Green Building/Energy Review Responses

Montgomery County
Department Of Permitting Services

Review Comments For:
Carpenter Shop Servant Quarters
2715 Cassidy Street
Silver Spring, MD 20910

A/P#: 725266+269 thru 272+274

2 PARTIAL ENLARGED TYPICAL STRUCTURAL PLAN @ 1ST, 2ND, NEW STAIR OPENINGS
S10.3 SCALE: 1/4" = 1'-0"

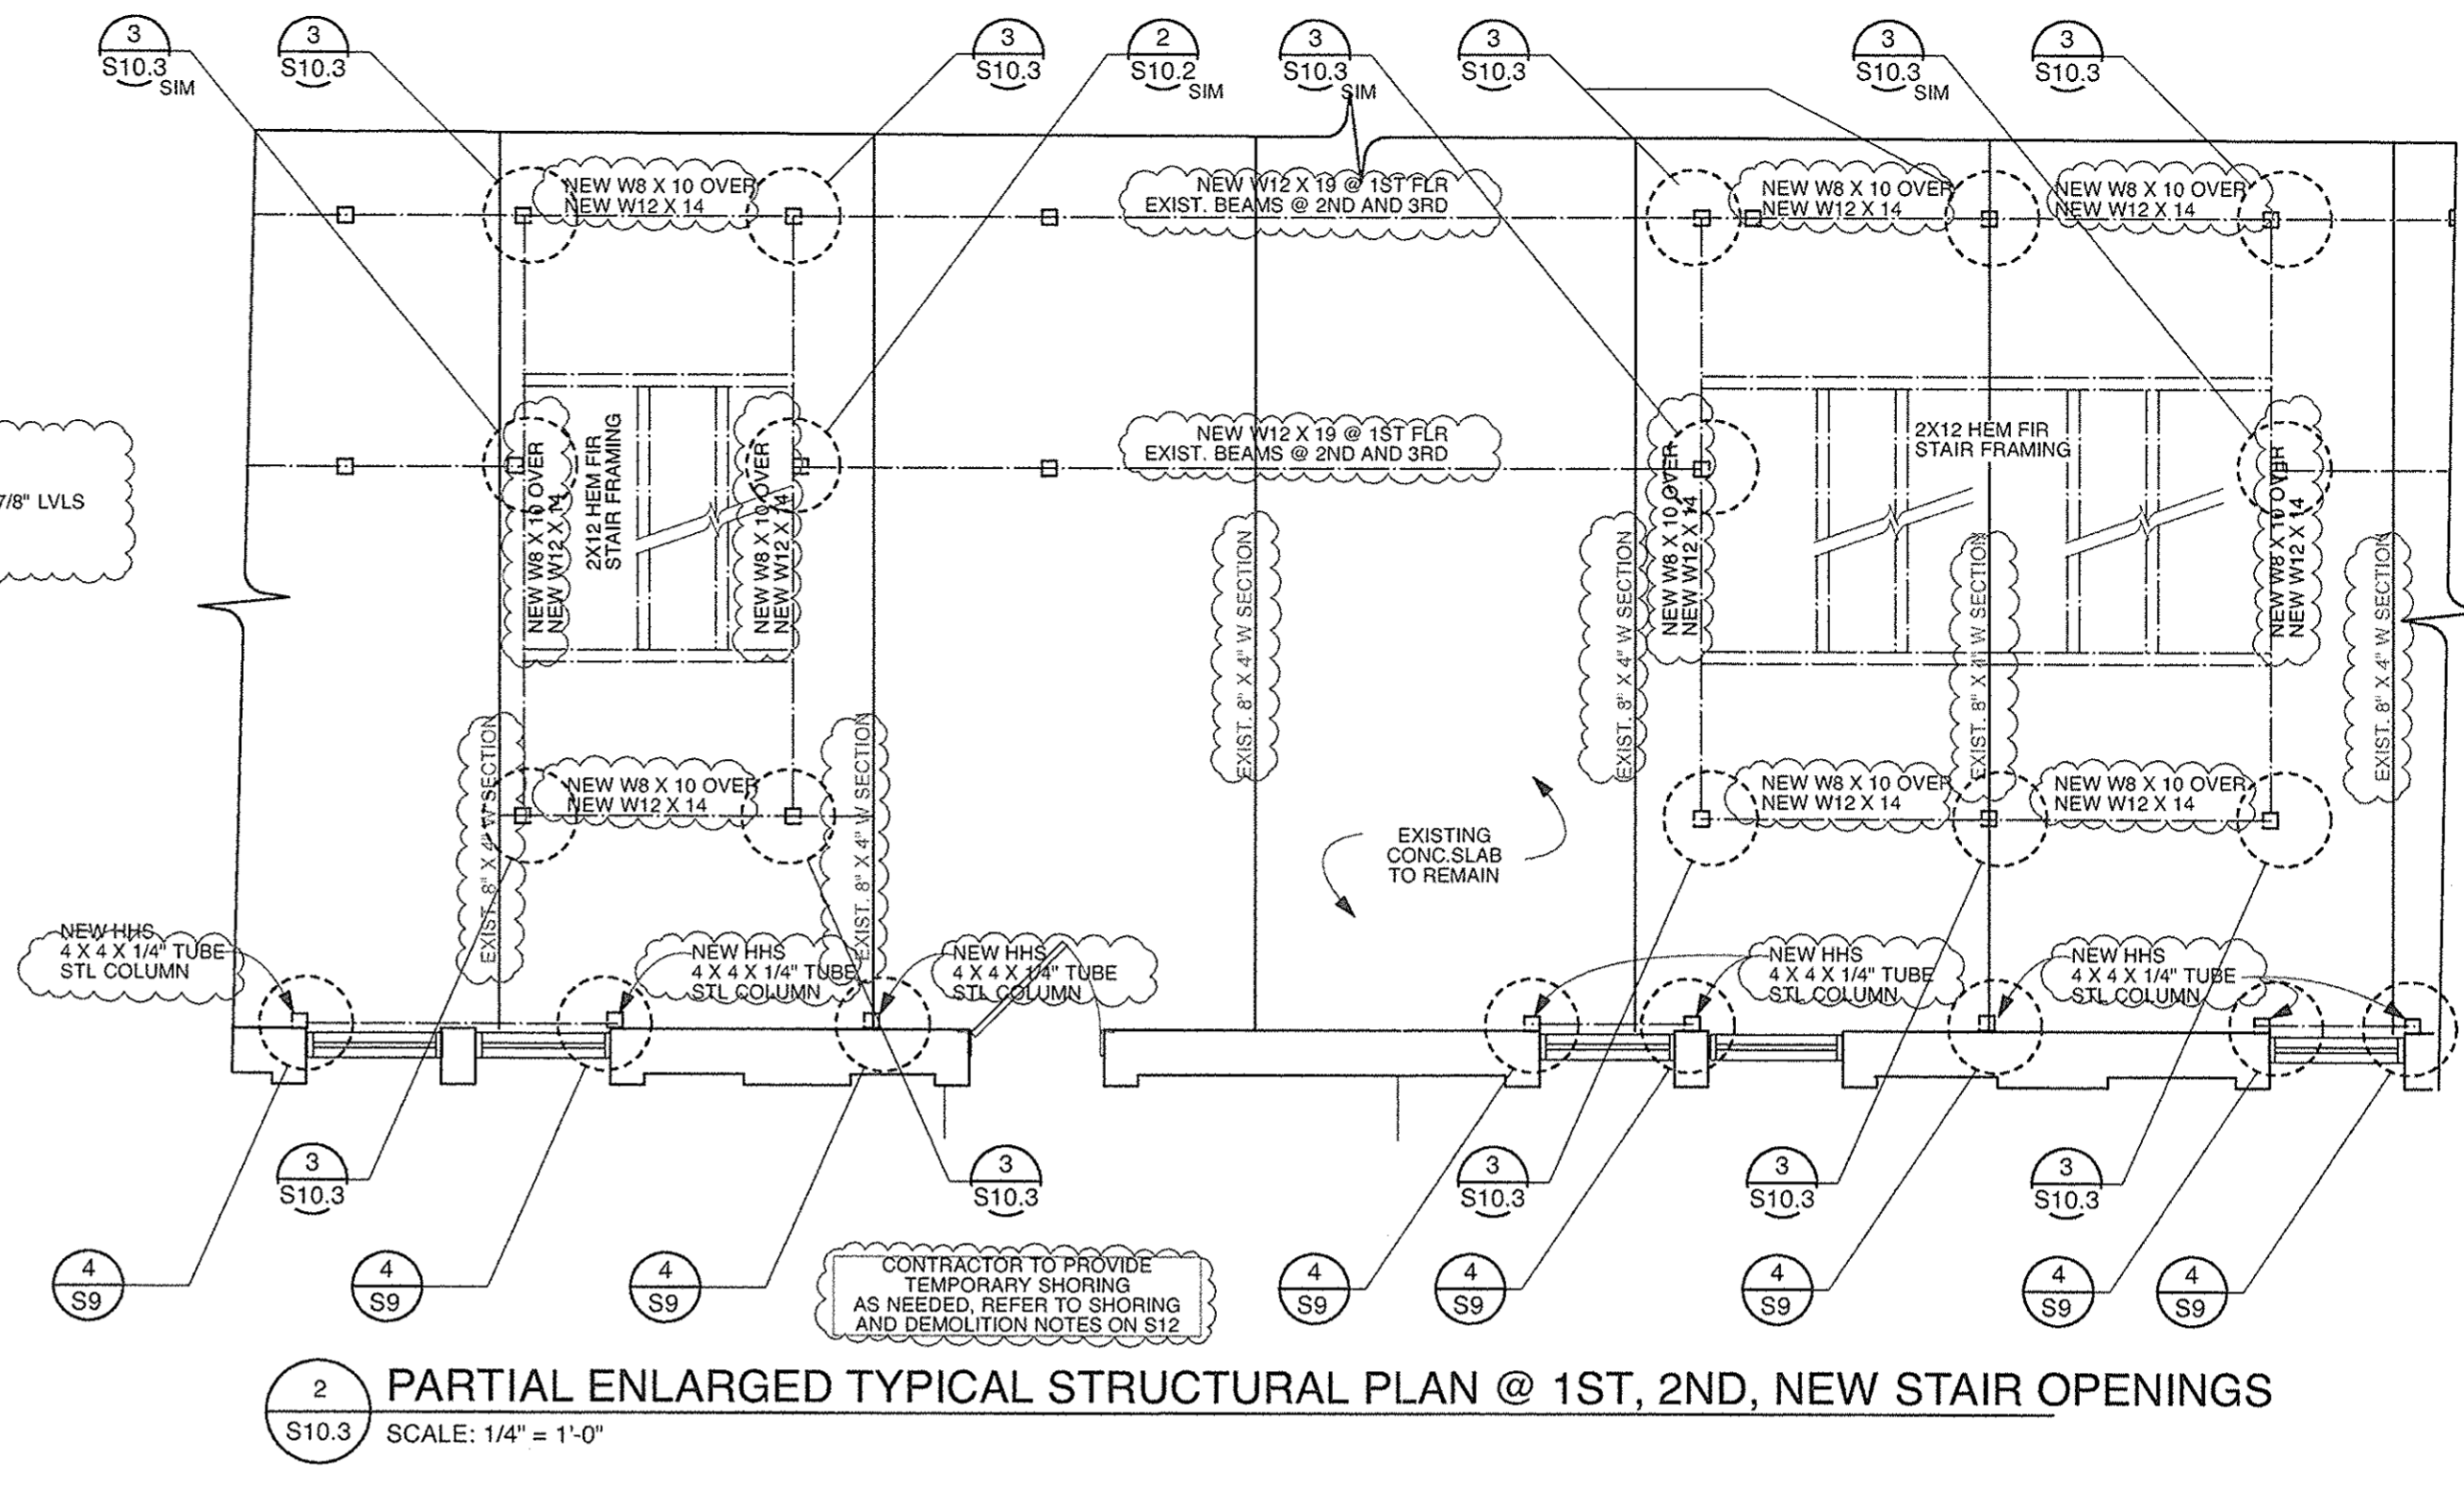
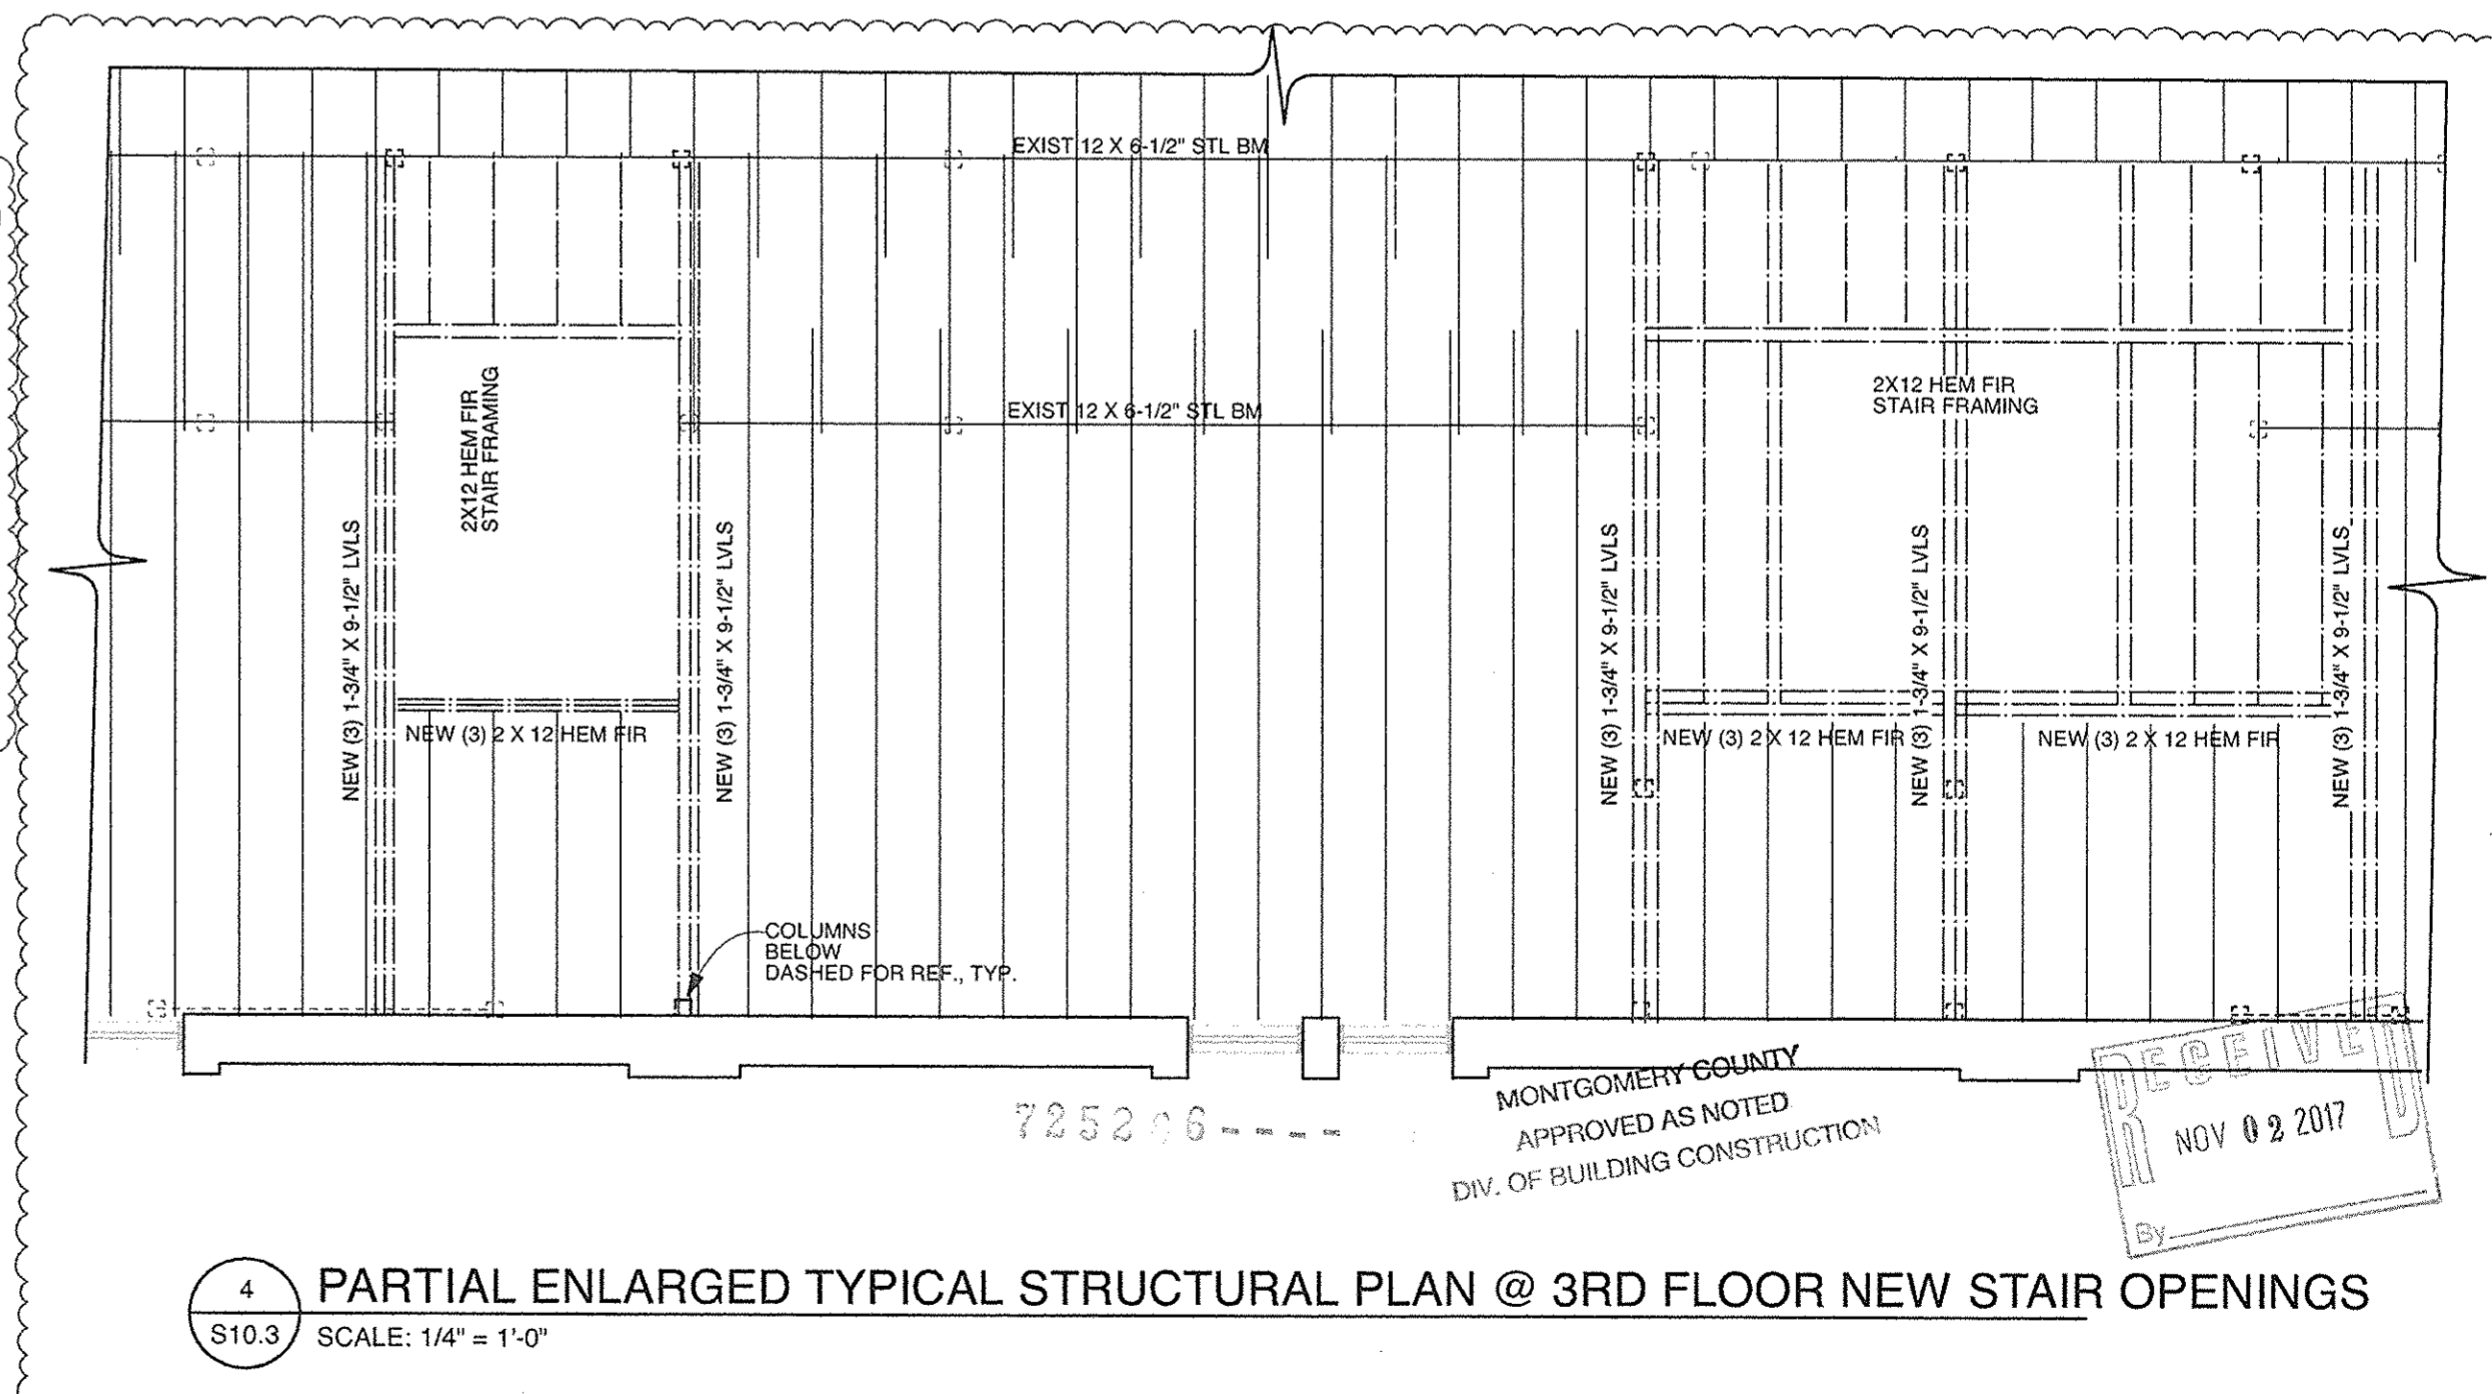
4. See previous comment, comments response not completed and no detailed explanation is provided. Detail shown on 10.3 does not provide any connection type and size between two bSER shall provide response in writing explaining the intend of detail shown. Provide temporary showing note on plan and under structural notes.

A) Detail shown on A10.3 revised to indicate connection between new W8 x 10 and New W12 x 14 to be 1/2" bolts @ 24" O.C.

A) Drawing 3/S10.3, AND 2/S10.3 -Plan updated to show existing and new structural conditions. See S12 under "Shoring and Demolition" for shoring notes associated with slab cuts.

B) Drawings 3/S10.3 AND 2/S10.3 Indicate " new 212 x 19 at first floor and existing beam at 2nd and 3rd. Per drawing 3/S10.3 the new W12 x 14 and the new W12 x 19 are at same elevation and connected via the steel plate and bolted connection as indicated on 3/S10.

MECHANICAL GENERAL NOTES

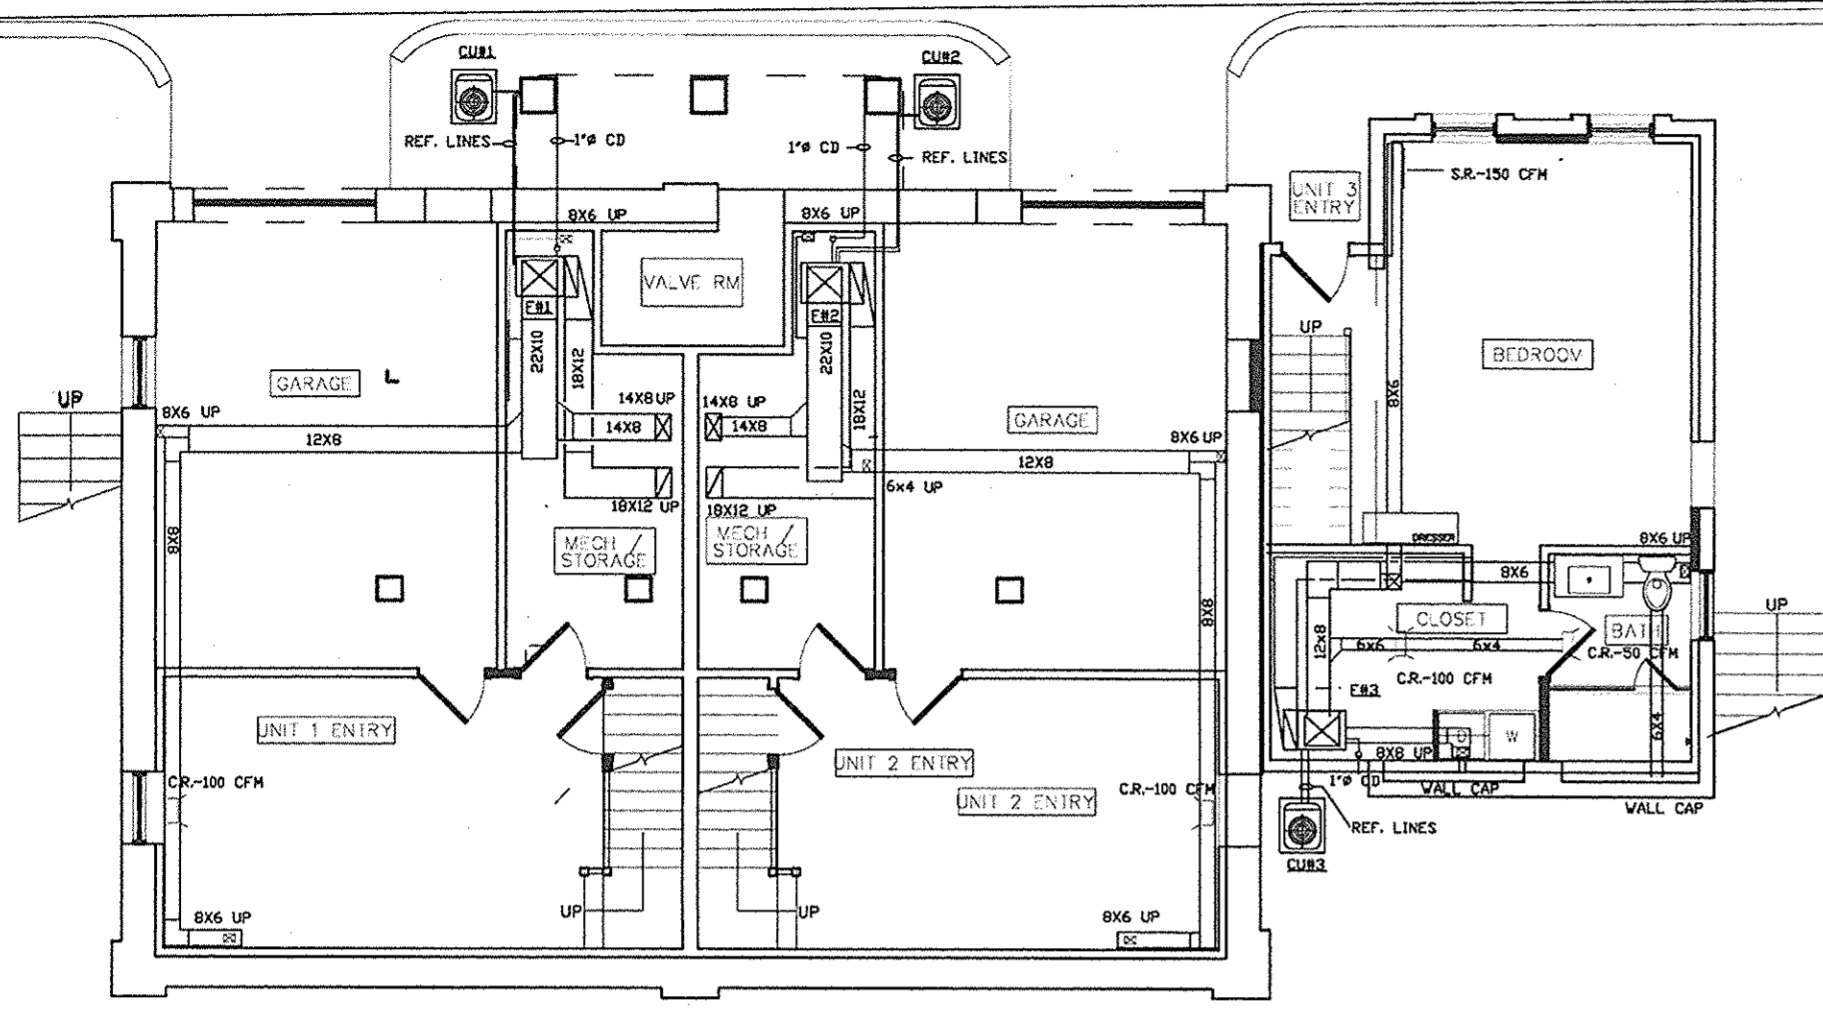
7. Specify insulation materials, R-values, sizes, etc., for the new ductwork per C403.2.9 and for the new piping C403.2.10.

- a. Insulation materials, R-values, etc are per IECC. See Sheet M-0
